**FORT WINGATE DEPOT ACTIVITY GROUNDWATER MONITORING
NORTHERN AREA BACKGROUND WELL INSTALLATION
LETTER WORK PLAN**

**FORT WINGATE DEPOT ACTIVITY
MCKINLEY COUNTY, NEW MEXICO**

December 30, 2017

**RE: APPROVAL WITH MODIFICATIONS
FINAL FORT WINGATE DEPOT ACTIVITY GROUNDWATER MONITORING
NORTHERN AREA BACKGROUND WELL INSTALLATION LETTER WORK
PLAN
FORT WINGATE DEPOT ACTIVITY
MCKINLEY COUNTY, NEW MEXICO
EPA ID# NM6213820974
HWB-FWDA-17-008**

Figure 3
Schematic of Proposed Well Construction

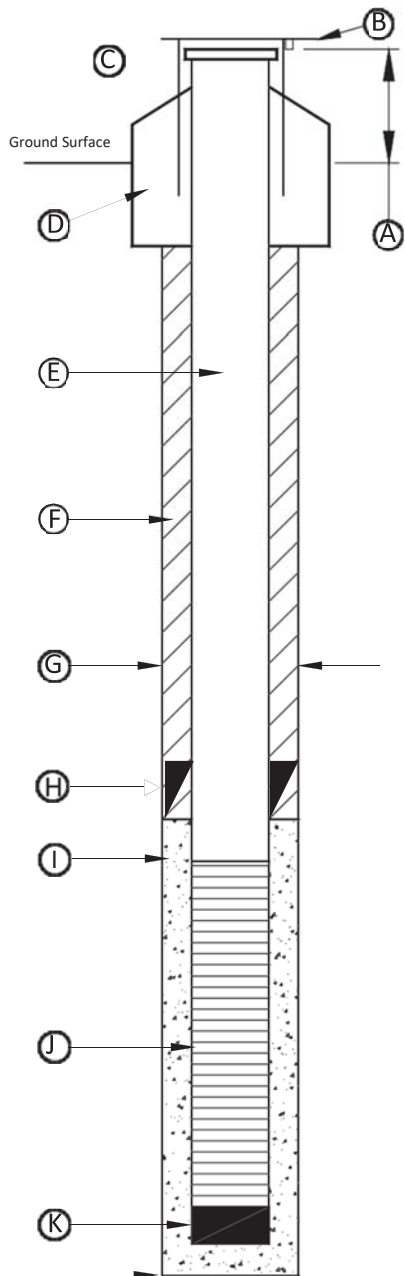
3. Figure 3, Schematic of Proposed Well Construction

NMED Comment: The schematic of proposed well construction in Figure 3 does not depict separate outer and inner casings. The Permittee must propose to install the wells with an appropriate seal or telescoped well casing in order to prevent cross-contamination between the alluvial and bedrock aquifers. Include the revised figure in a response letter.
